ADDENDUM NO. 3

TRACK & FIELD IMPROVEMENTS – INC 1

Hueneme High School

December 2, 2019

(E-100)AD3-E2

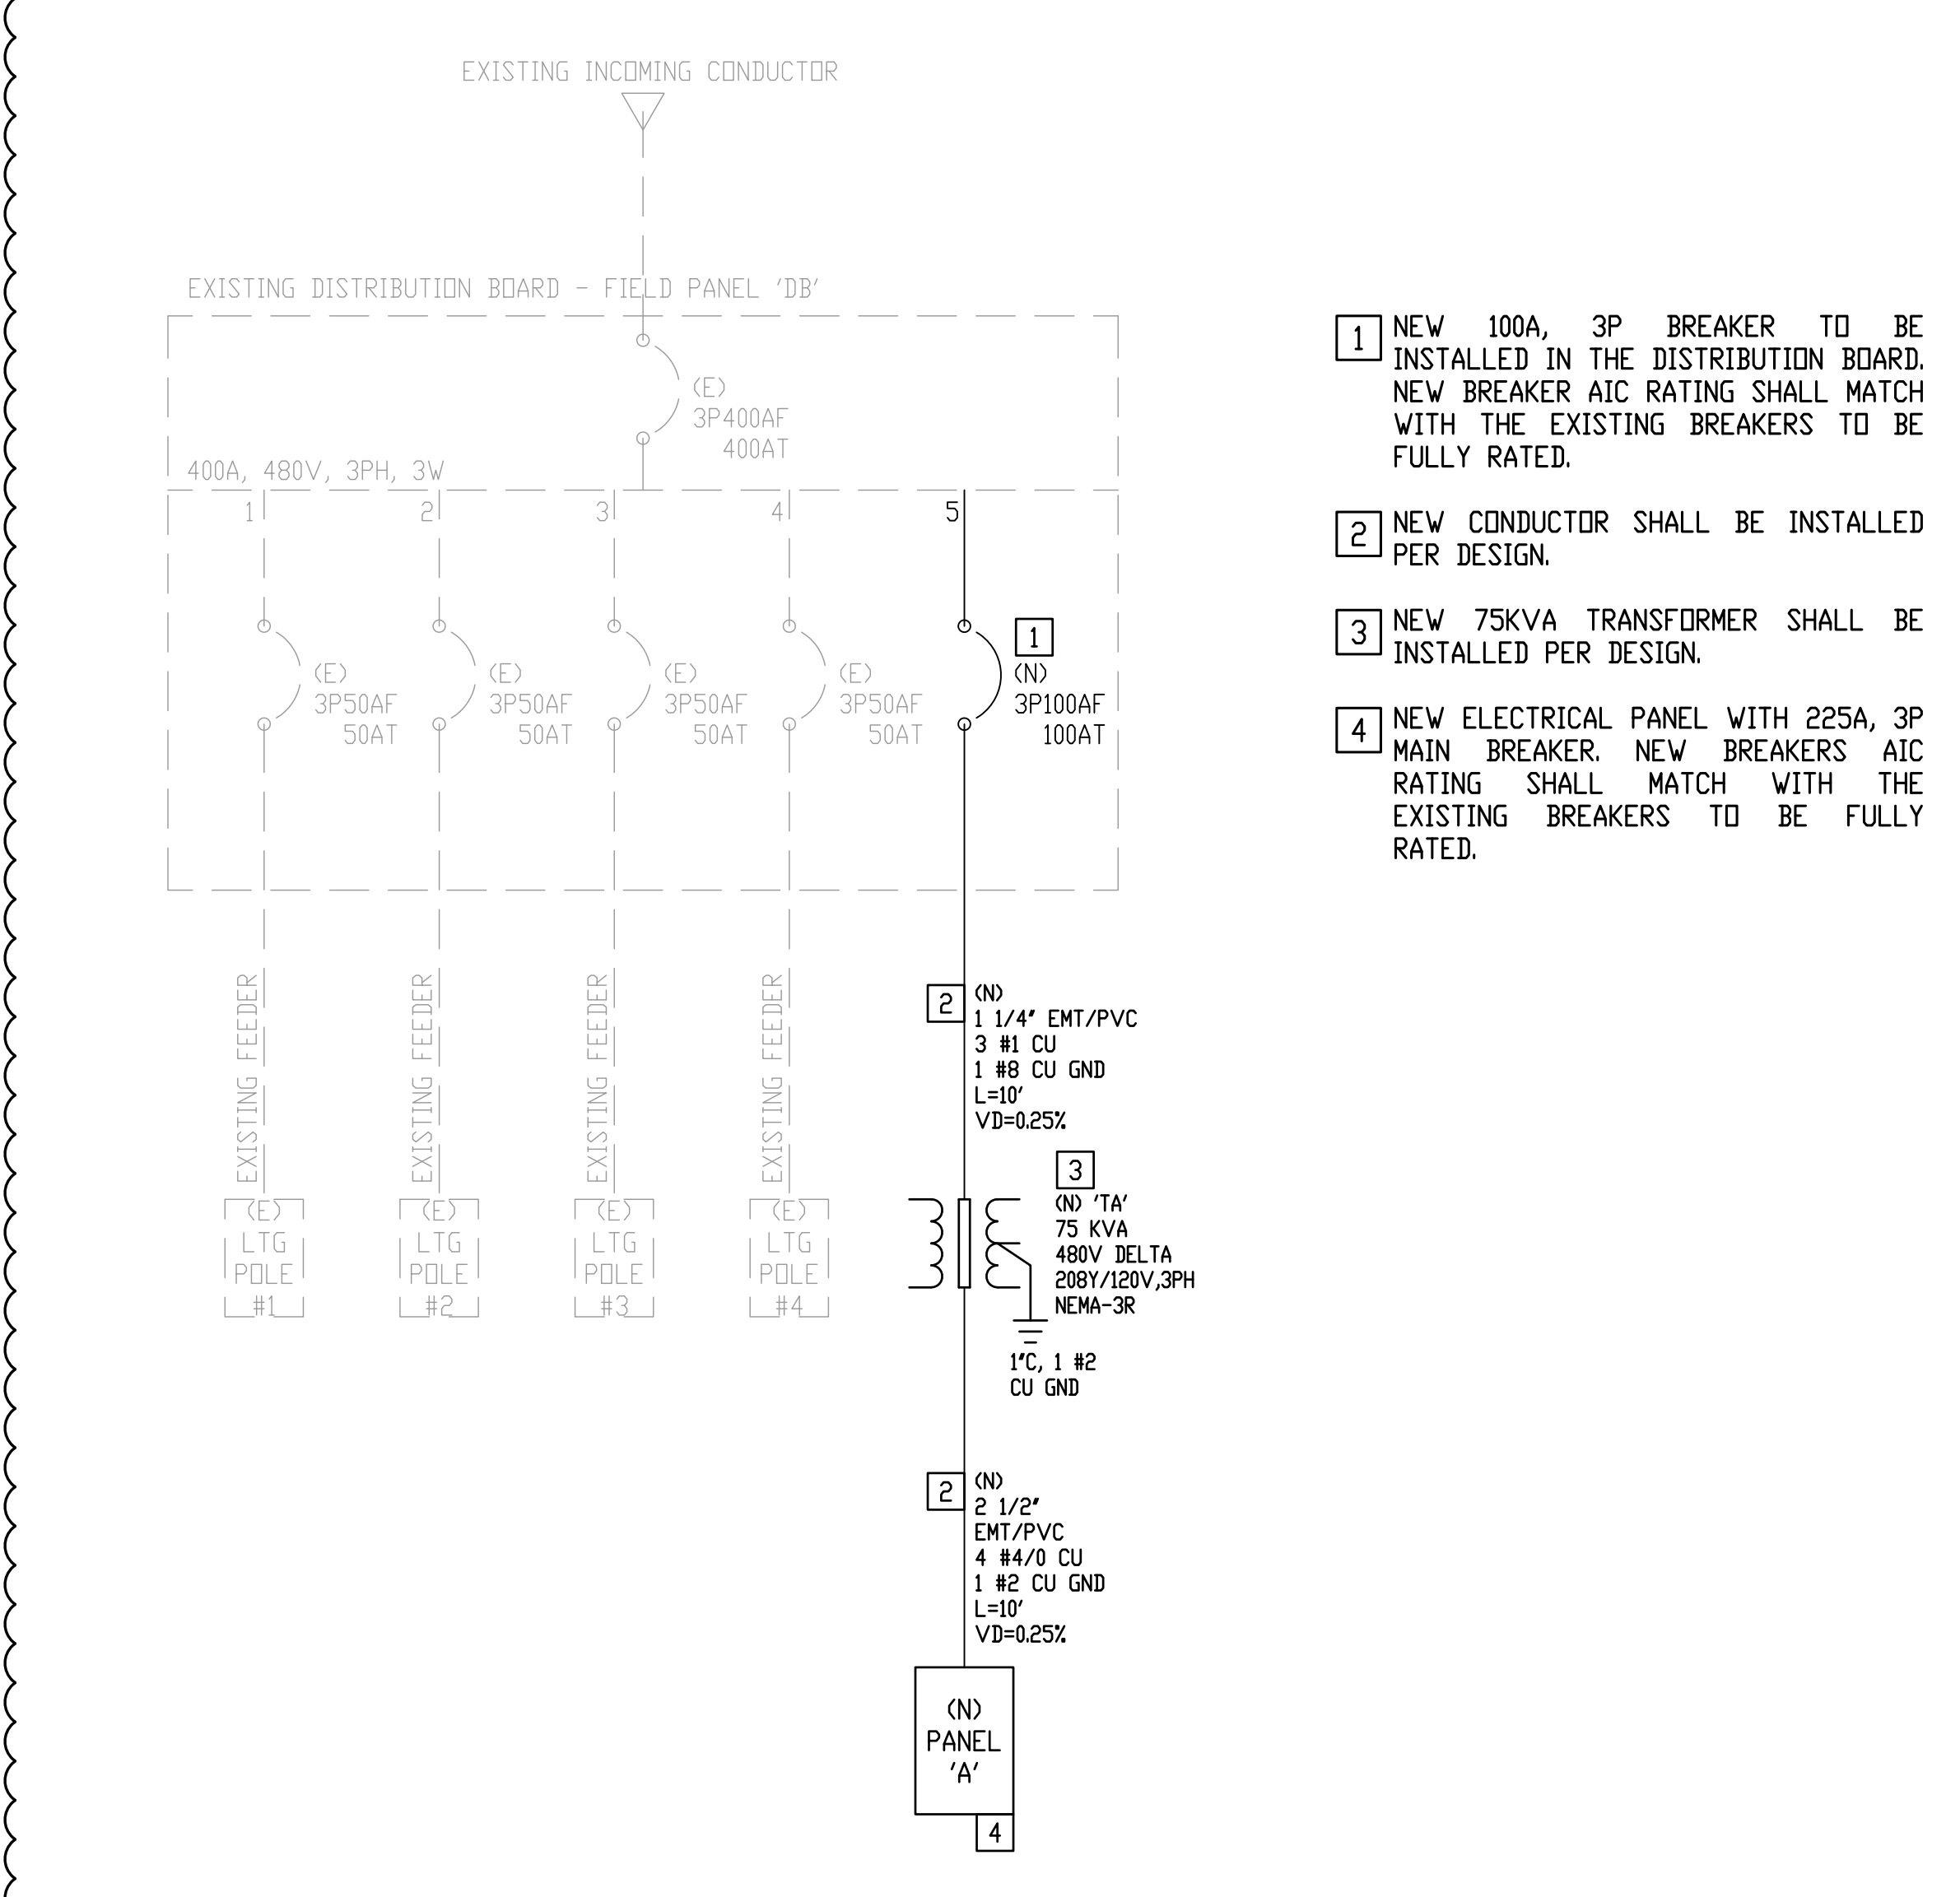
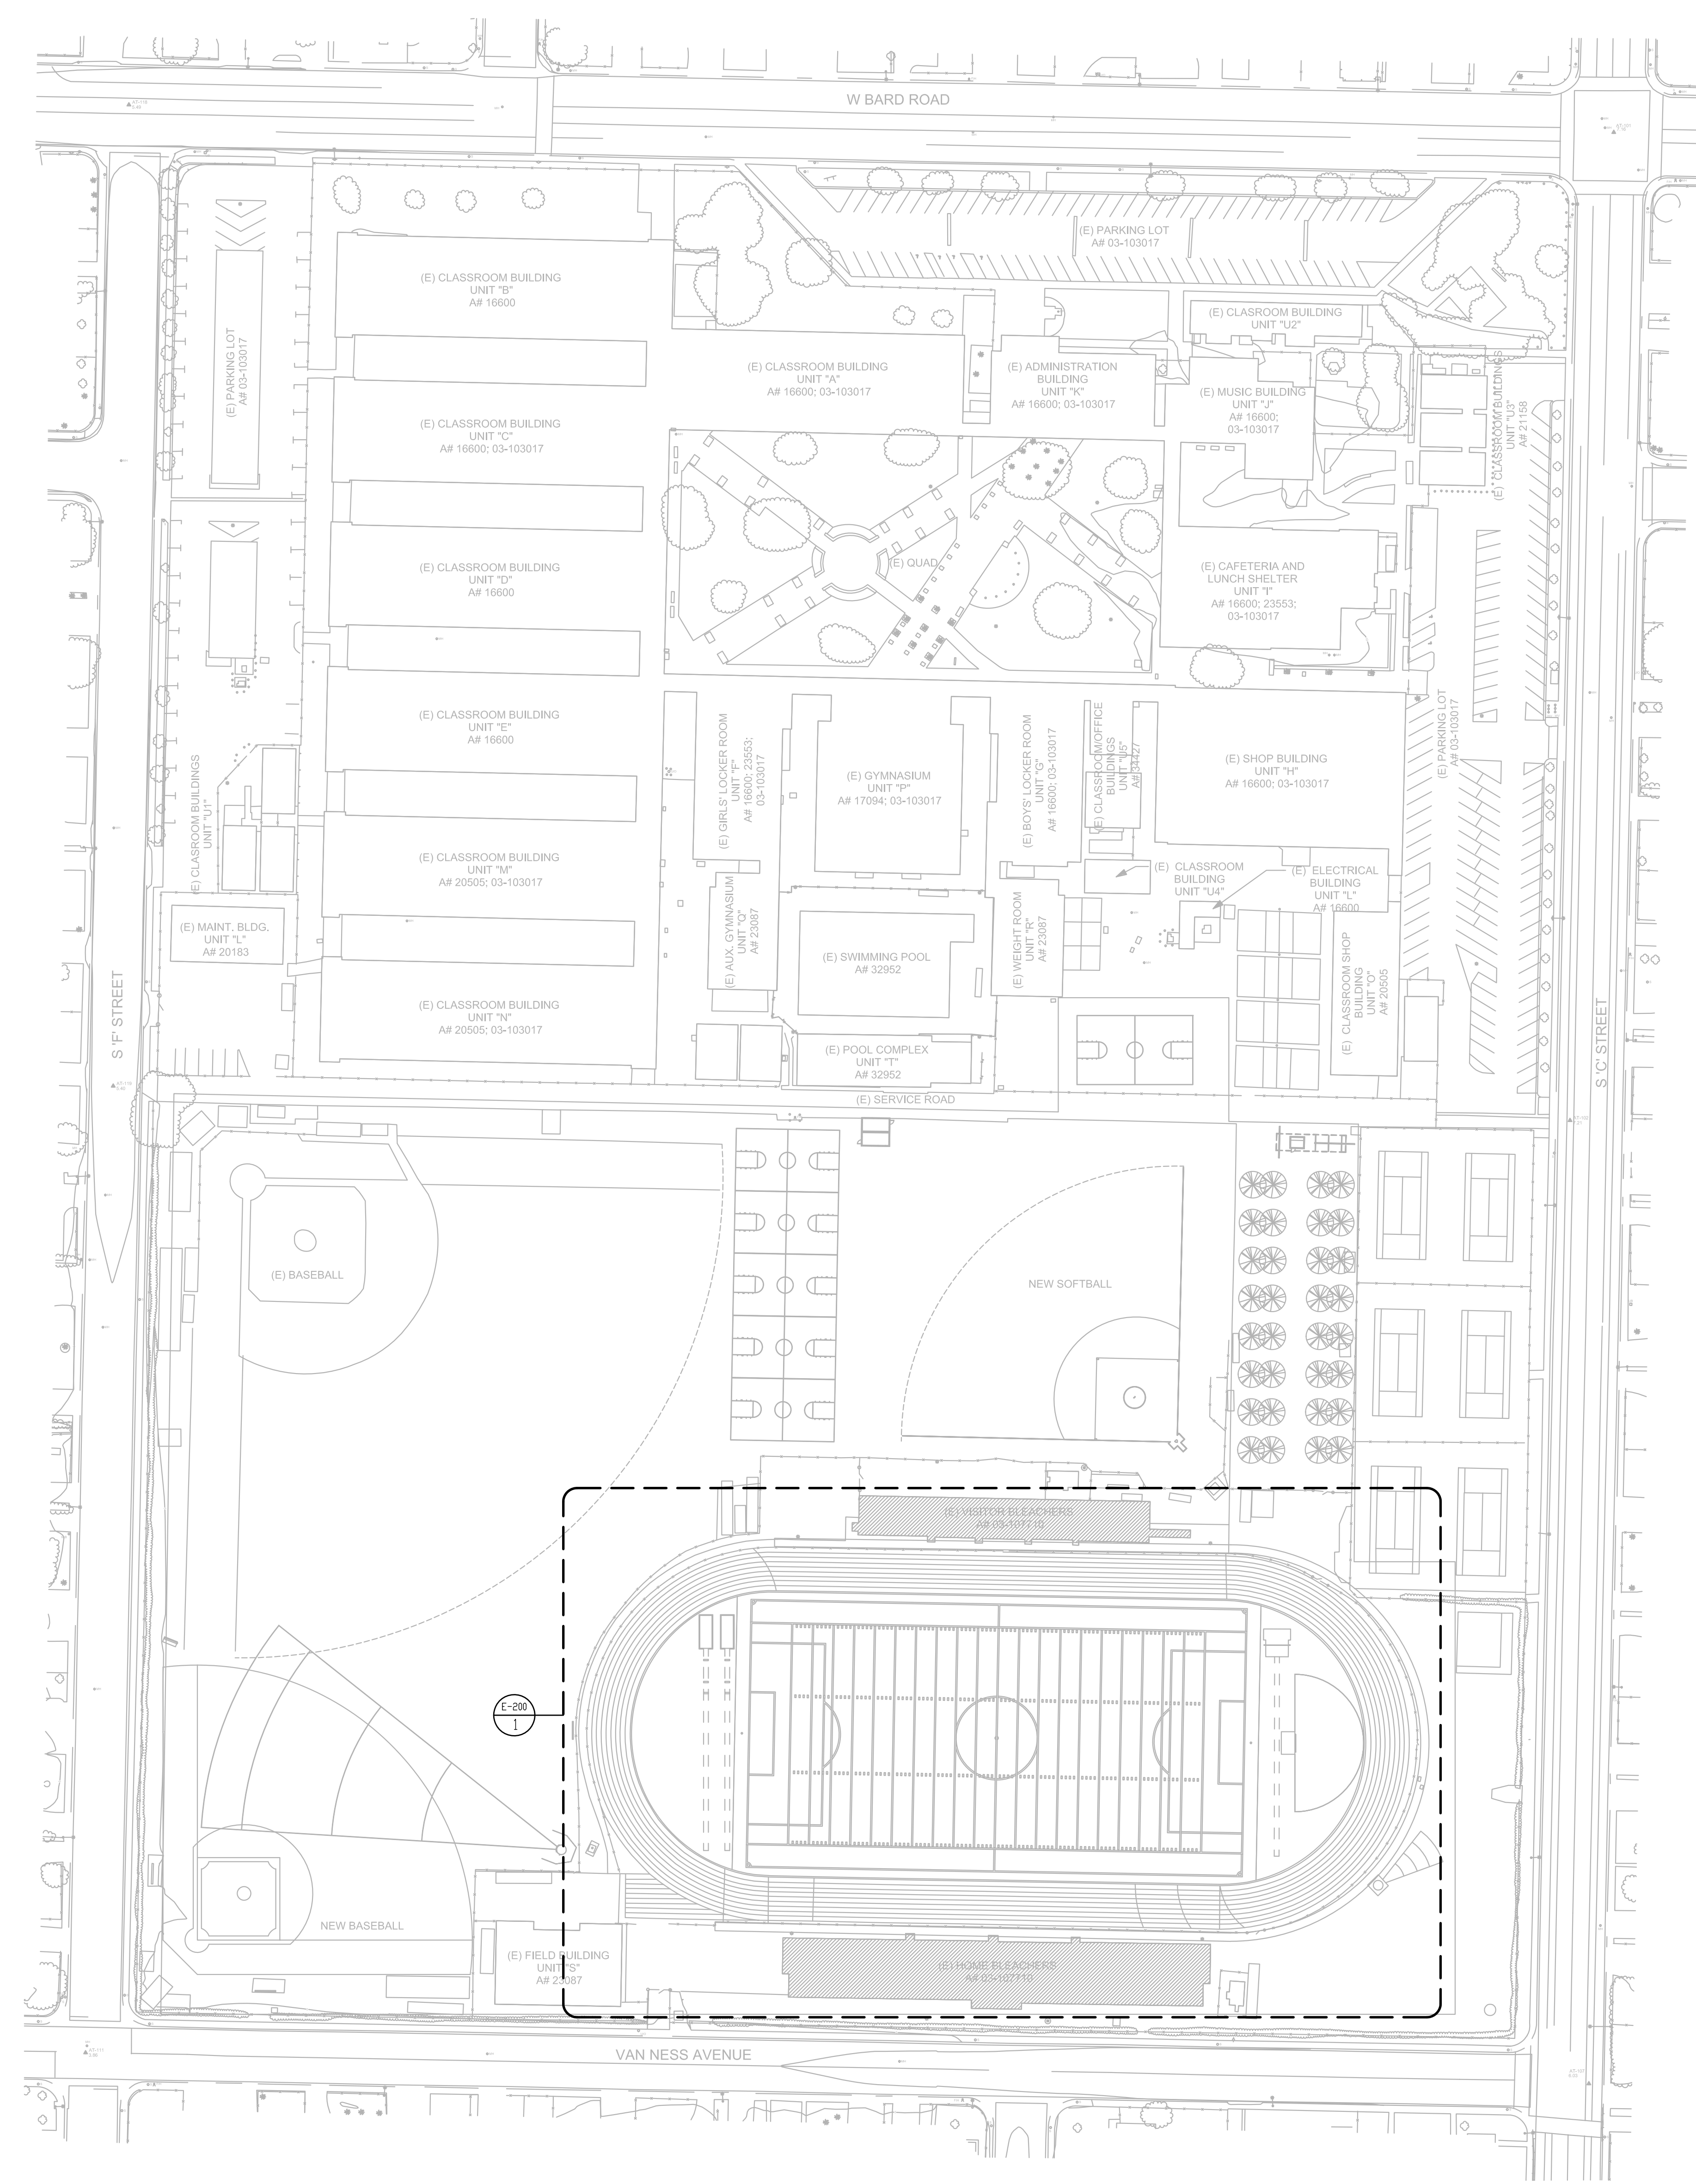
3.2.2.1.1. New and existing panels and electrical equipment are shown on sheet E-100 (AD3-E2) & E-200 (AD3-E3).

(E-200)AD3-E3

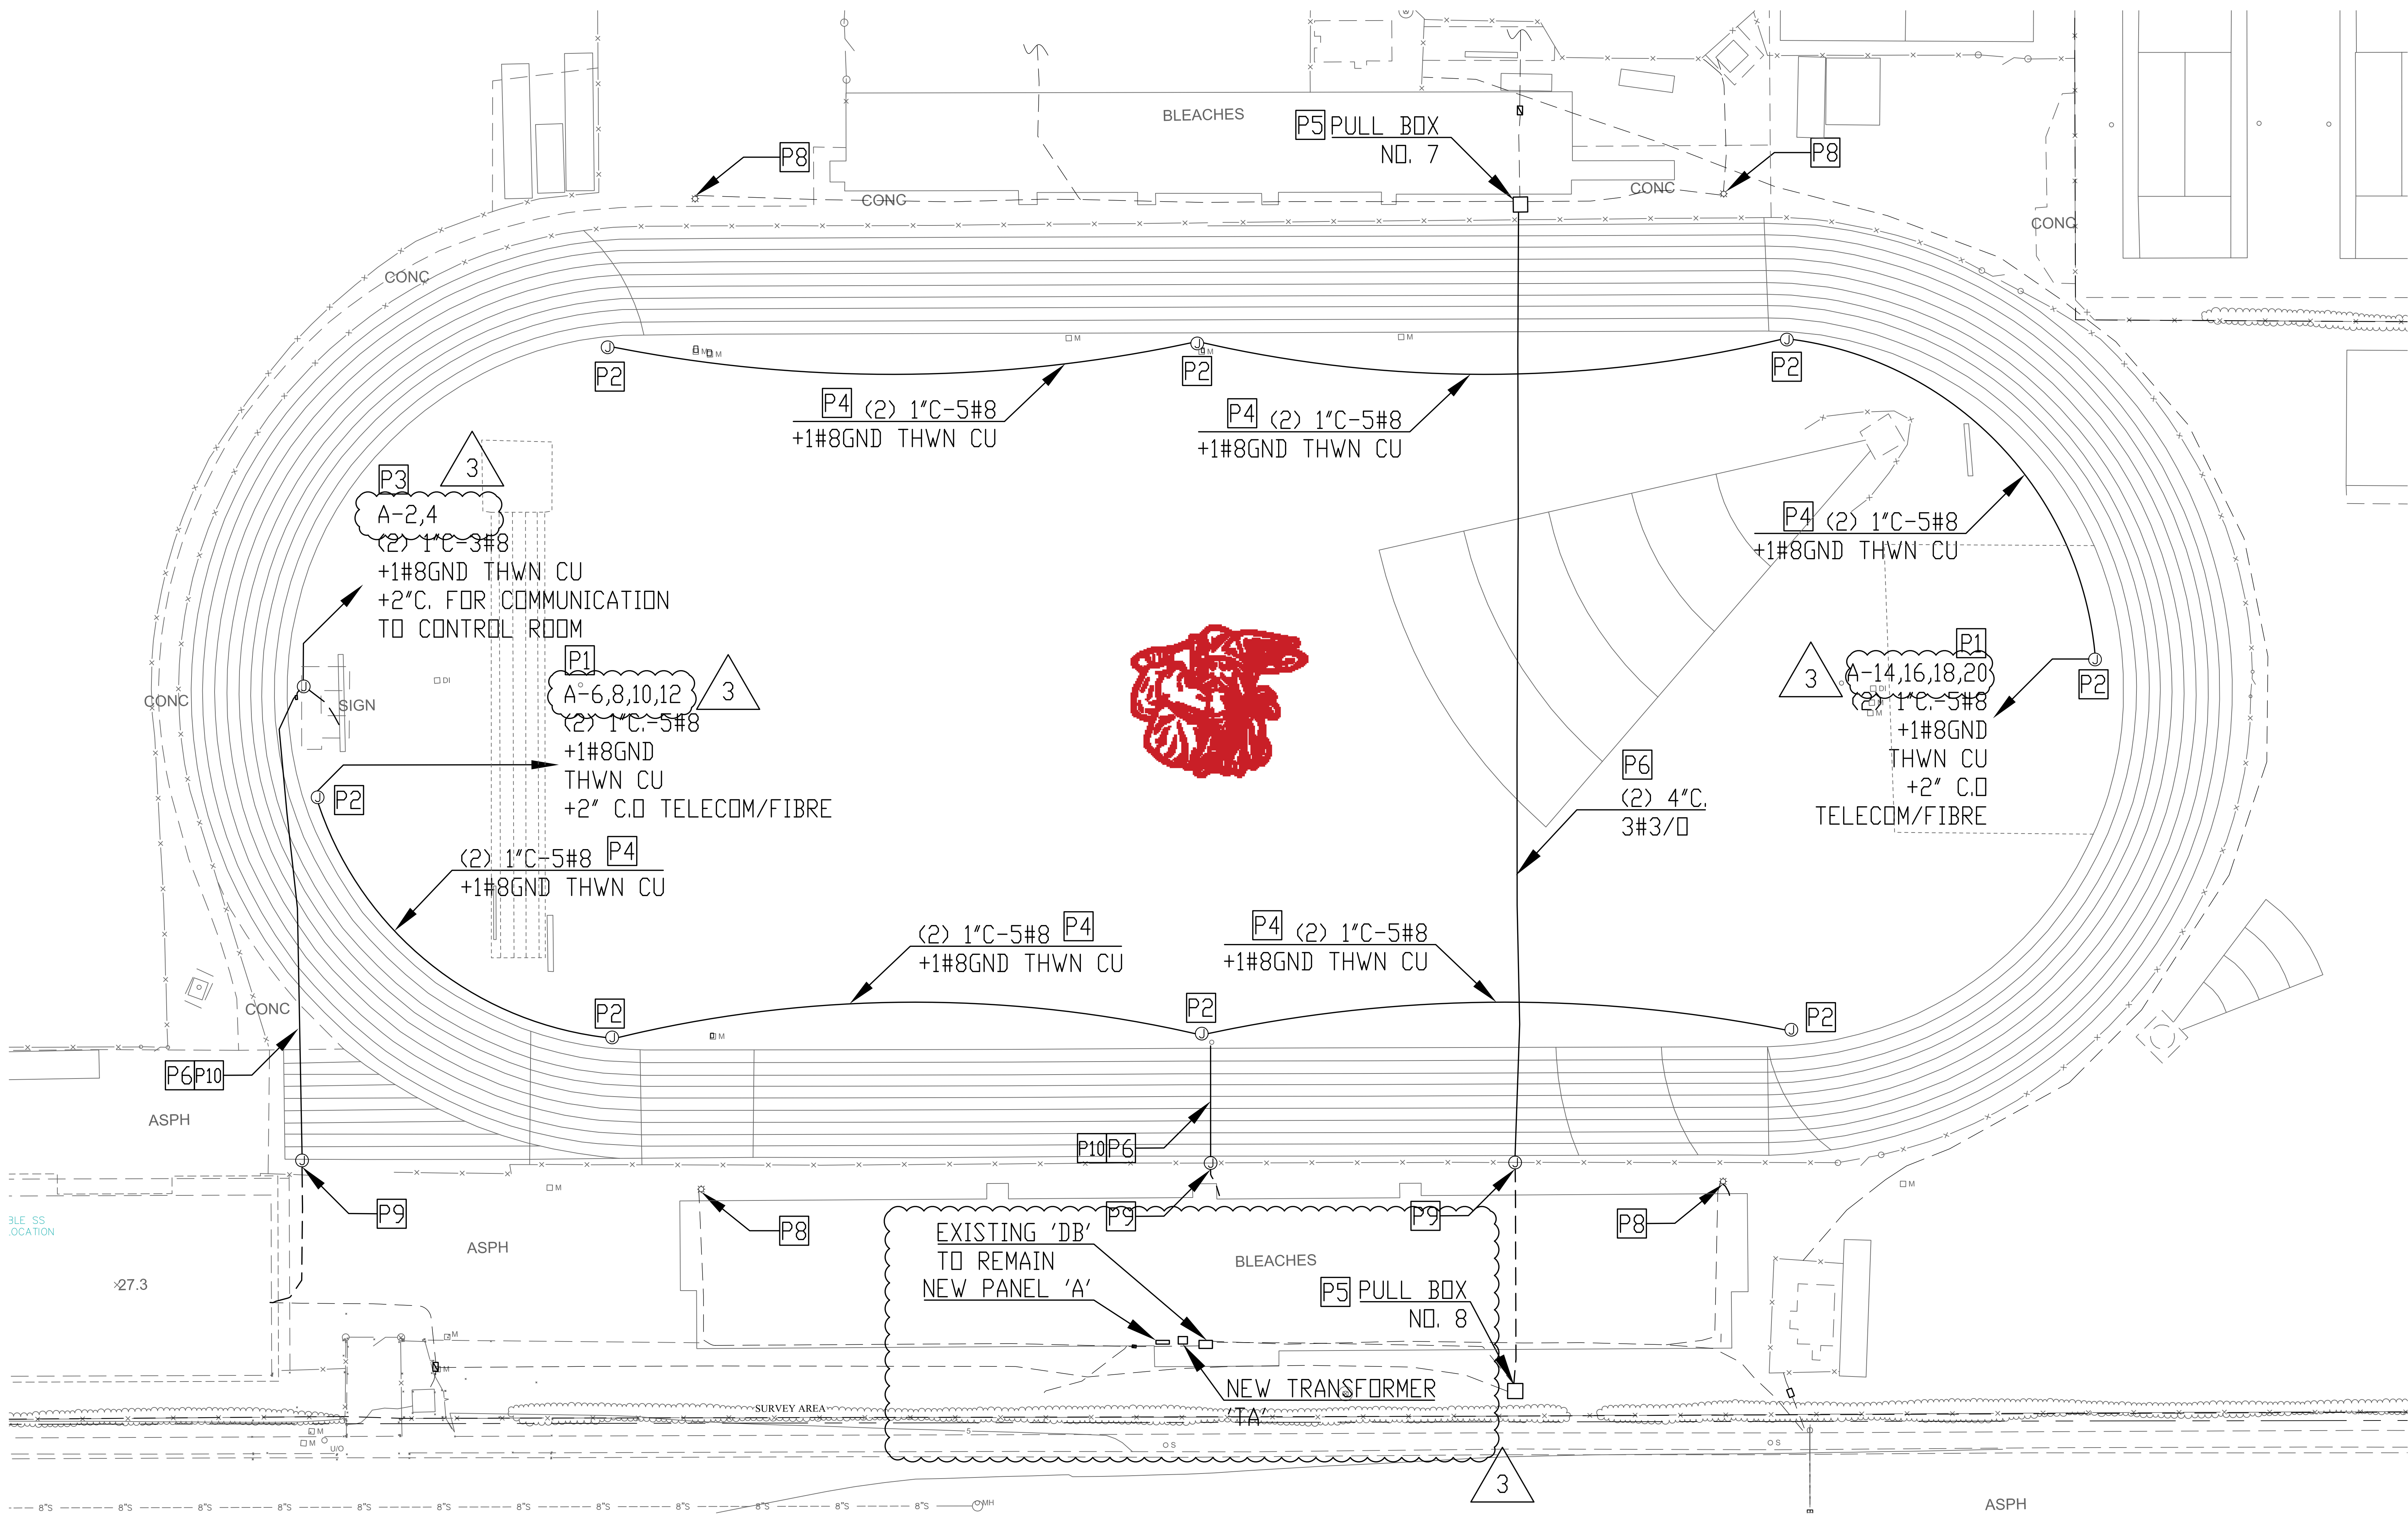
3.2.2.1.2. Refer to note P5 on sheet E-200 (AD3-E3) for proposed minimum sizing of the junction boxes. Also, refer to sheet AD3-E1 and AD3-E3 for quantity & size of conduit connected to each junction box, to determine box size at each location.

3.2.2.1.3. Contractor to refer to note P8/E200 (AD3-E3) to clarify removal of Stadium Light Fixtures and speakers, cap wire at existing connections and deliver fixtures and speakers to District.

- P8 AT EXISTING LIGHT POLES, REMOVE ALL STADIUM LIGHT FIXTURES AND SPEAKERS, CAP ALL THE WIRES AND CONNECTIONS. DELIVER REMOVED FIXTURES AND SPEAKERS TO DISTRICT.
